Subject: EA12-005 File Update (Chrysler Jeep Fuel Tank System Safety Defect) *

Subject:	EA12-005 File Update (Chrysler Jeep Fuel Tank System Safety Defect)
Reference 1:	3 June 2013 Letter of ODI Director Frank S. Boris to Chrysler Group LLC
Reference 2:	Chrysler Group LLC 'White Paper on NHTSA's Recall Request' (4 June 2013)

Figure 1

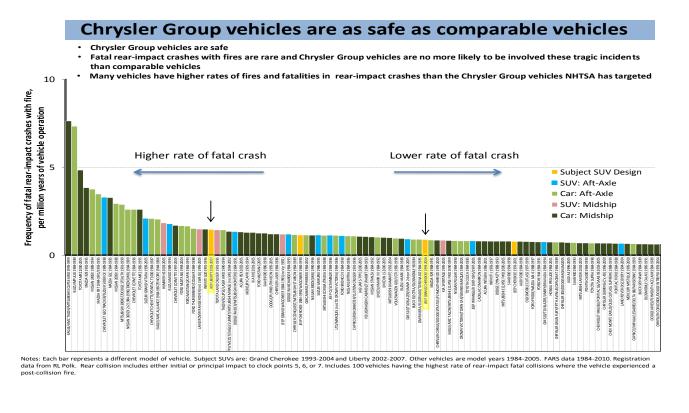
Data from NHTSA's Fatality Analysis Reporting System show 24 models – none of which has been subjected to recall – are more likely to be involved in a fire-related, rear-impact fatality than the 2002-2007 Jeep Liberty; 54 models are more likely than the 1993-2004 Jeep Grand Cherokee. (*See Figure 1.*)

Initial FARS Assessment - Rear Impacts with Fire

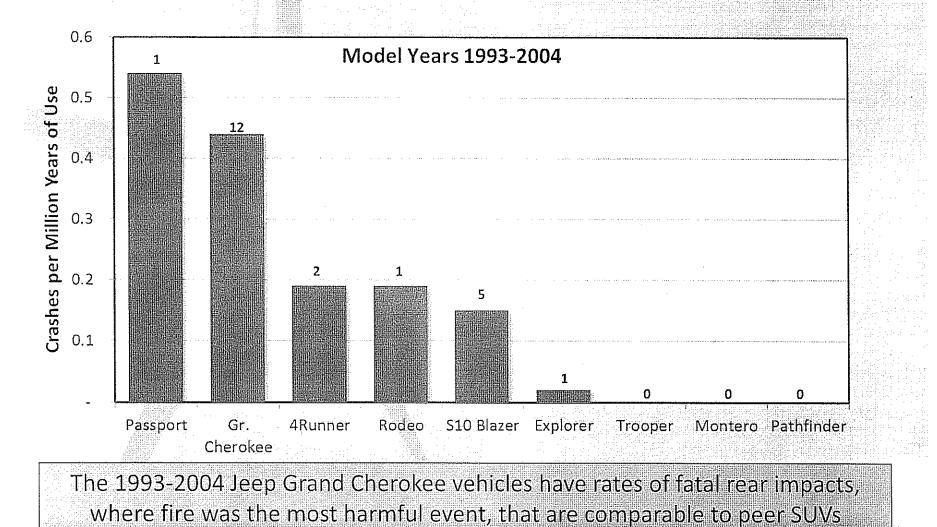
My original ZJ-Body to Explorer multiplier was estimated at 22:1. It was based on the very same exhibits that Mr. Dillon presented to NHTSA on 16 April 2011 (Attachment 5). However, the ZJ-Body data has been corrected by Reference 1, and we must now revise the ZJ-Body to Explorer peer vehicle fire-death multiplier:

This revised estimate presumes that the Explorer data on Dillon Exhibit 16 is still 1, but utilizes the Reference 1 fire-death total of 29 for the ZJ-Body. On this basis the revised ZJ-Body to Ford Explorer multiplier is 54:1.
